DEVELOPMENT REVIEW COMMITTEE (DRC) COMMENT REPORT

PROJECT NAME: Suntrust Center at Las Olas Square

CASE NUMBER: R19021

REQUEST: Site Plan Level II Review: Downtown Signage

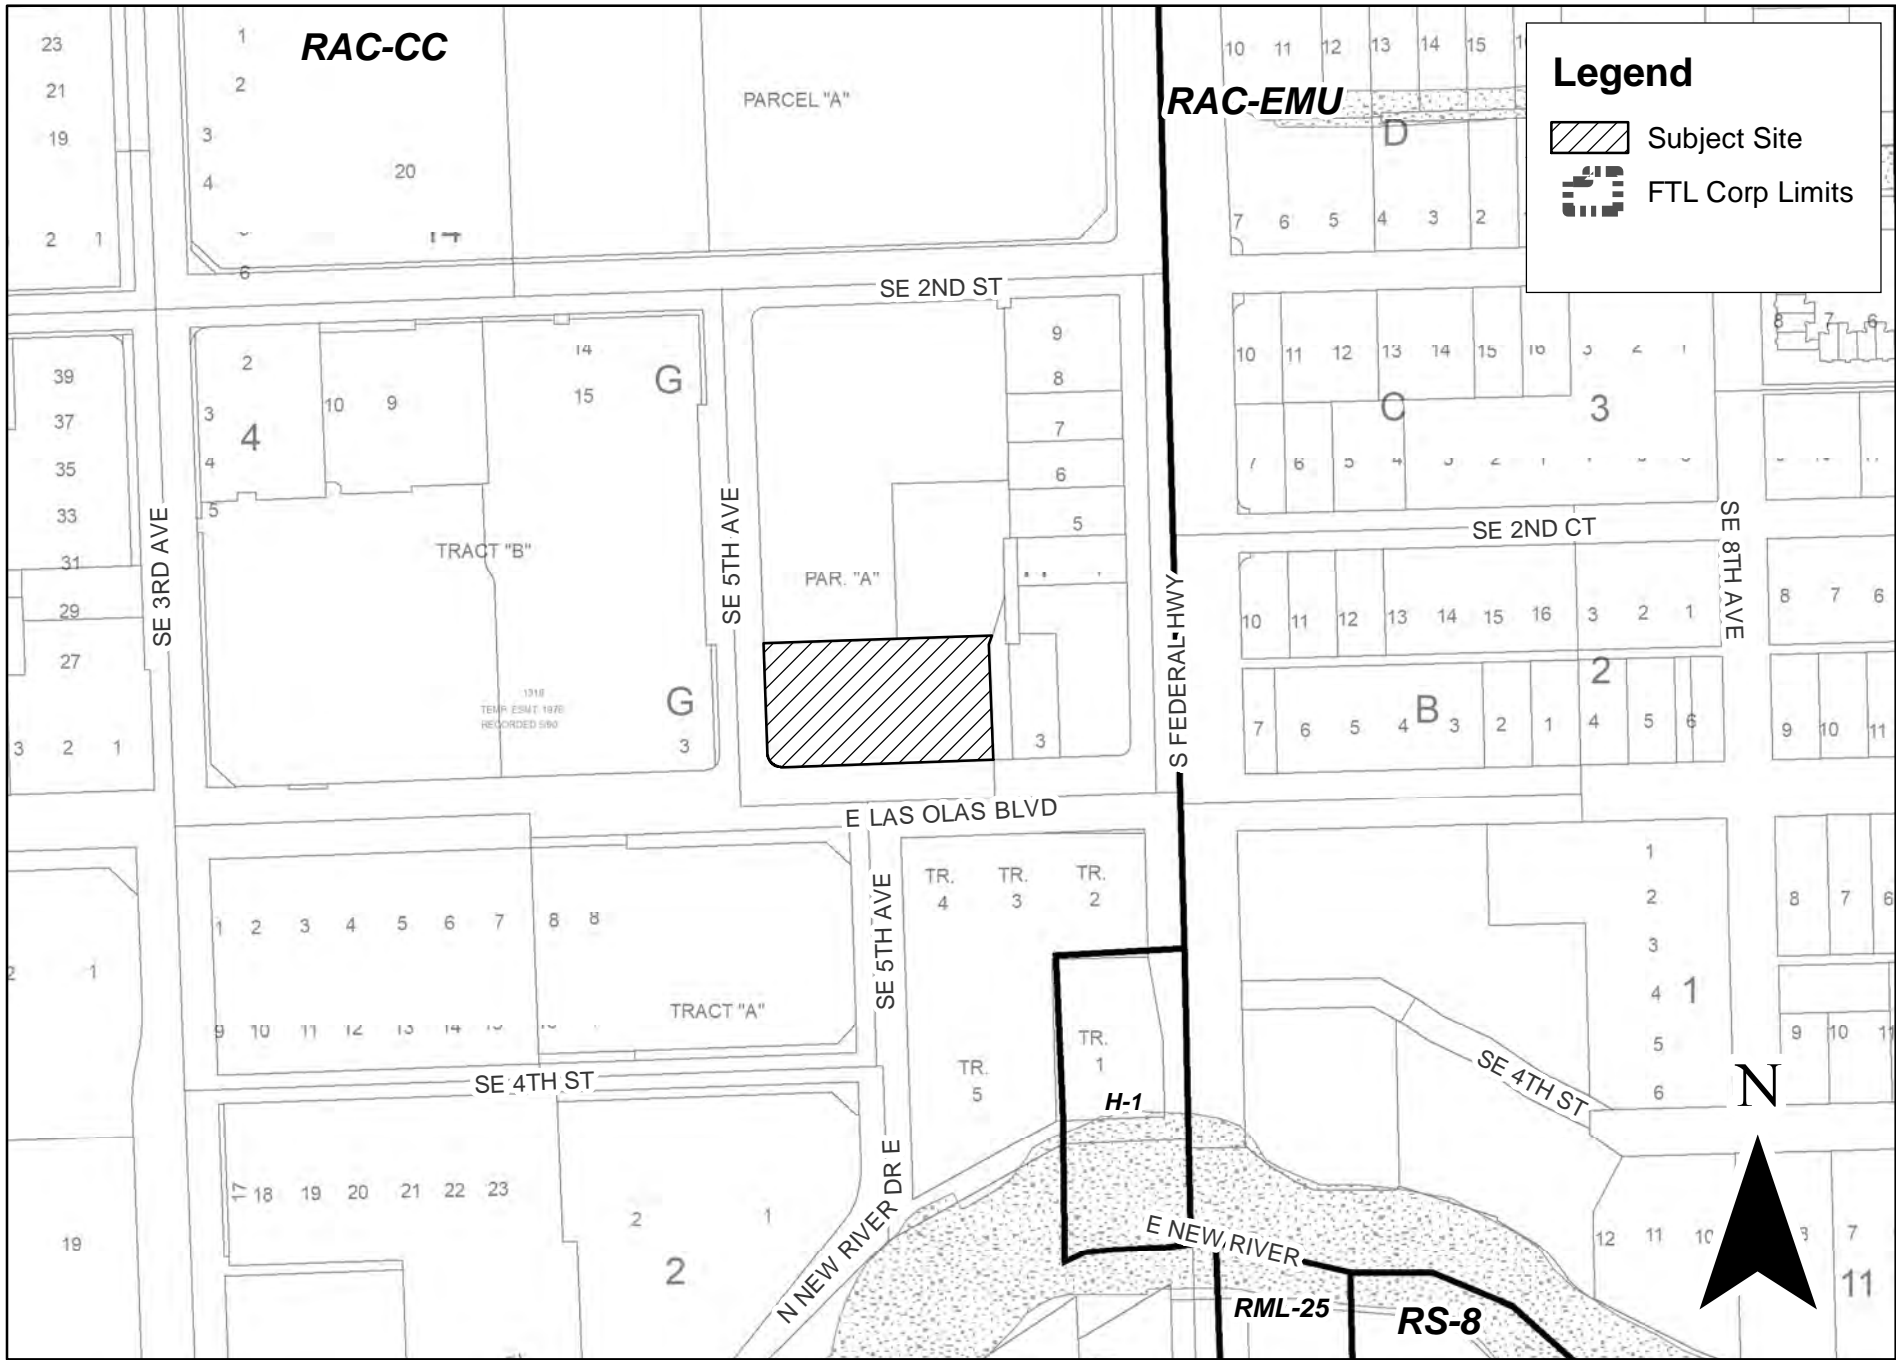
4. The internally-illuminated monuments with push-thru copy do not appear to rise to the level of exceptional quality of the rest of the project. If it is felt that this signage type is consistent with the architectural design, finishes and landscape design of the project, provide perspectives in both day and nighttime to support notion of consistency of design and finishes. Alternatively, a sign design commensurate with the quality of the rest of the project is encouraged.
